ADMINISTRATIVE AMENDMENT (PD) ADD2026-00035

ADMINISTRATIVE APPROVAL
LEE COUNTY, FLORIDA

WHEREAS, Rvi Planning + Architecture filed an application on behalf of Heights Land Company, Inc. for administrative approval on a project known as Crosslands Commercial Planned Development (CPD) to incorporate a deviation from Land Development Code (LDC) Section 30-153(3)e, which requires identification signs to be set back a minimum of 15 feet from any right-of-way, to allow a 10-foot setback from Gladiolus Drive, at the property located at 10940 Gladiolus Drive, Fort Myers, described more particularly as:

1. **Development must be consistent with the six (6) page amended Master Concept Plan, titled "Heights Career Technical School at Crosslands CPD", a copy of which is attached hereto as Exhibit "B".**

EXHIBIT B

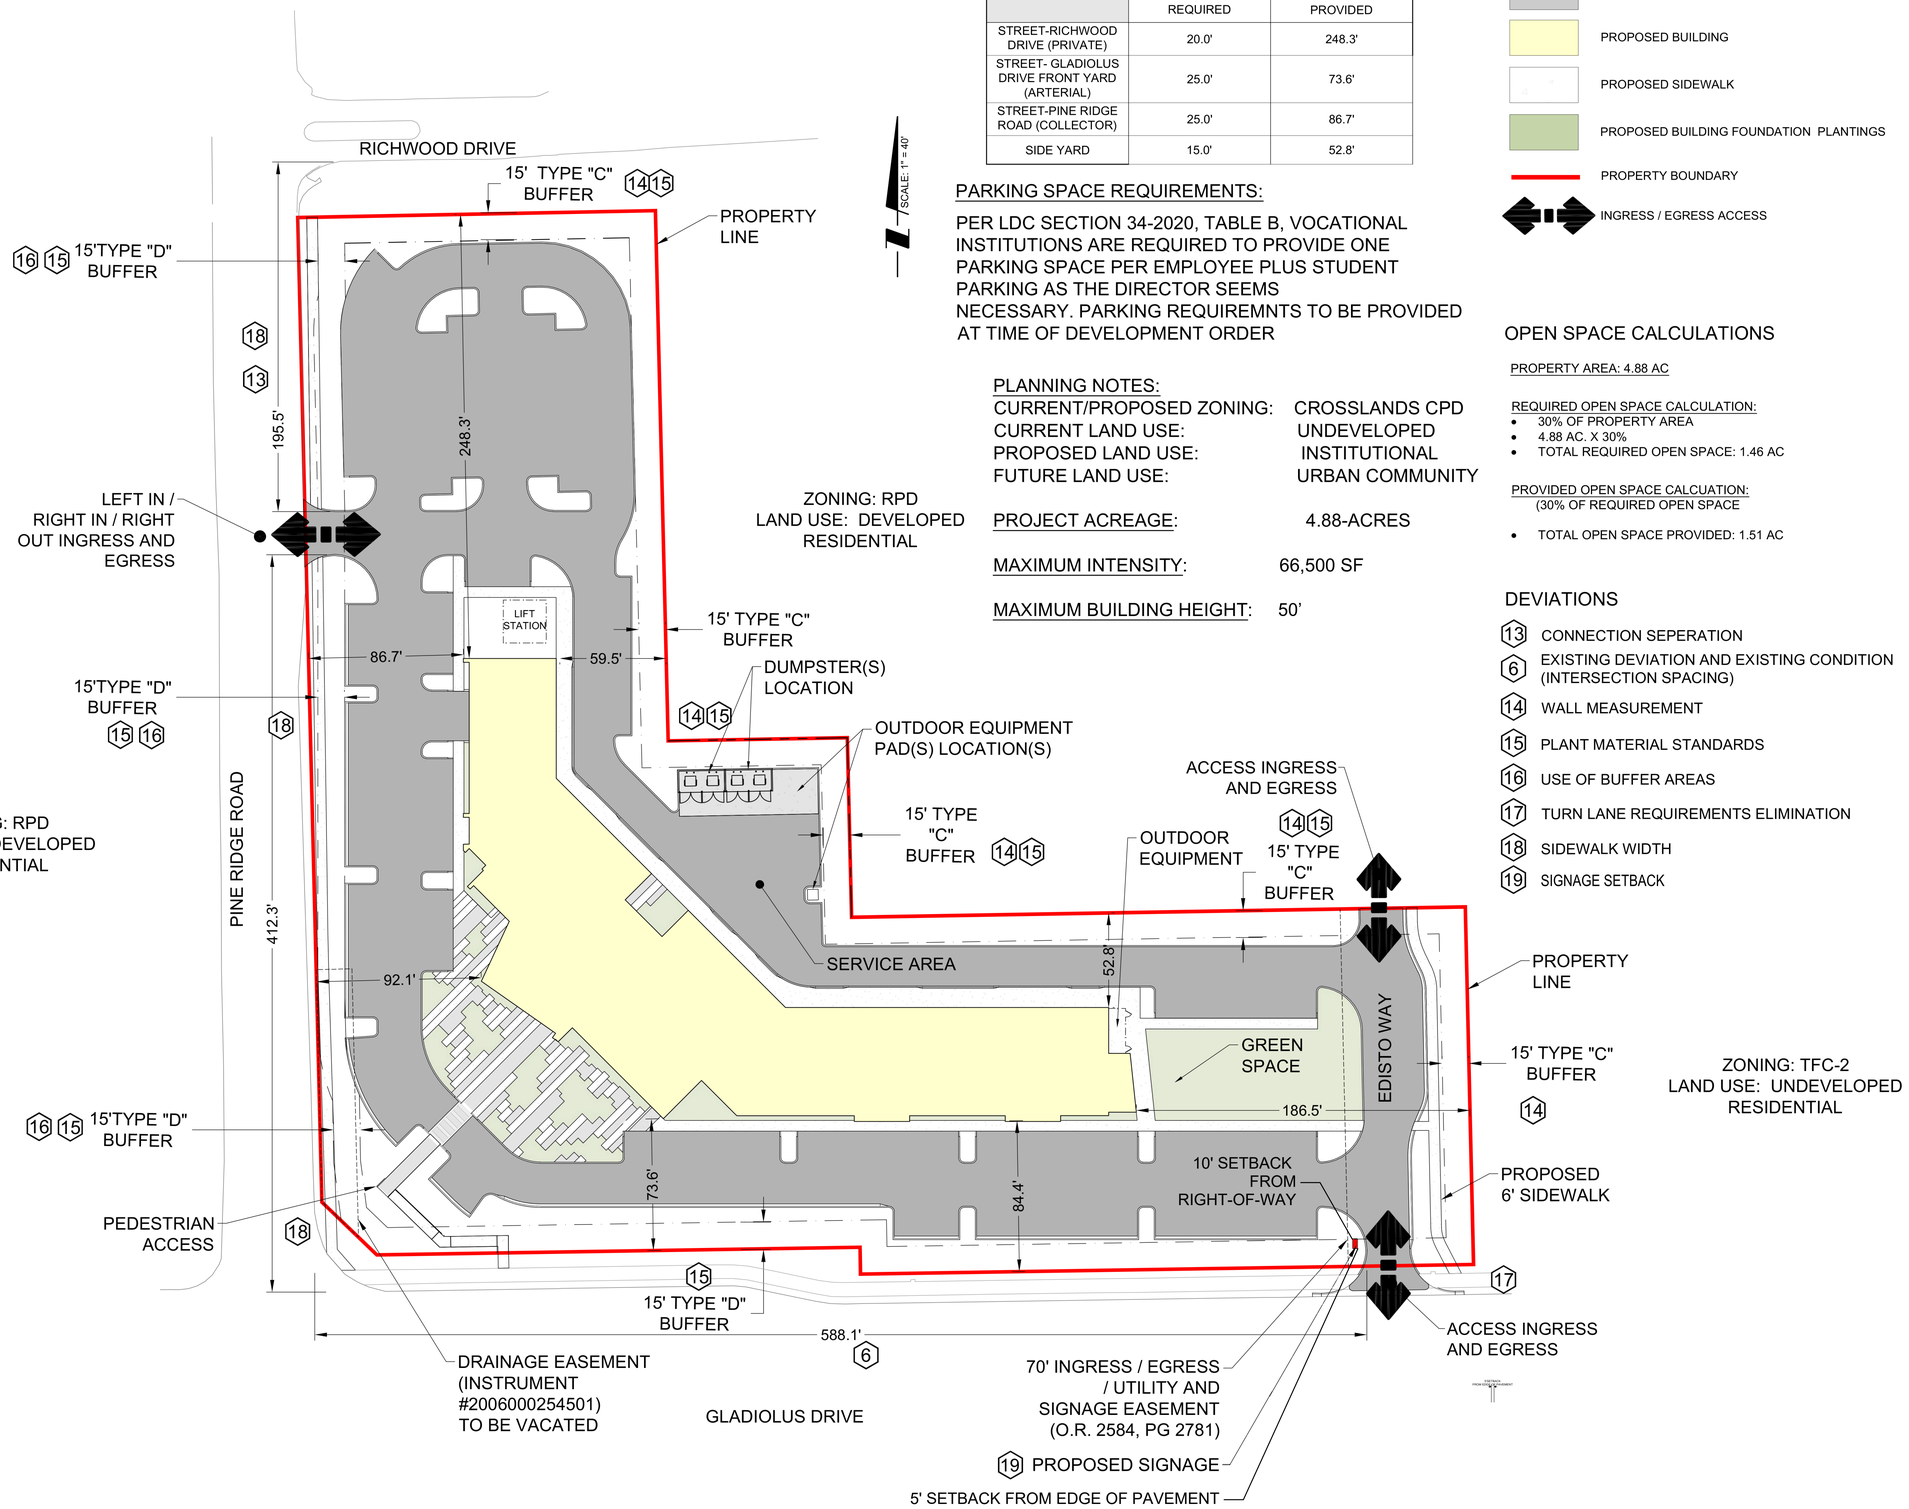
WHEREAS, the applicant has requested a deviation (Deviation 19) from LDC Section 30-153(3)e, which requires identification signs to be set back a minimum of 15 feet from any right-of-way, to allow a 10-foot setback from Gladiolus Drive; and

WHEREAS, the reduced setback does not obstruct visibility or interfere with established line of sight lines for vehicular or pedestrian traffic at the proposed location depicted on the Master Concept Plan (MCP) (see Exhibit “B”); and

WHEREAS, the Gladiolus Drive right-of-way includes an 8-foot-wide pathway that provides separation between the sign and travel lanes, further protecting public safety as it pertains to wayward vehicles; and

2. **Deviation 19 from LDC Section 30-153(3)e., to allow a 10-foot street right-of-way setback is hereby APPROVED, limited to the location annotated on the Master Concept Plan.**
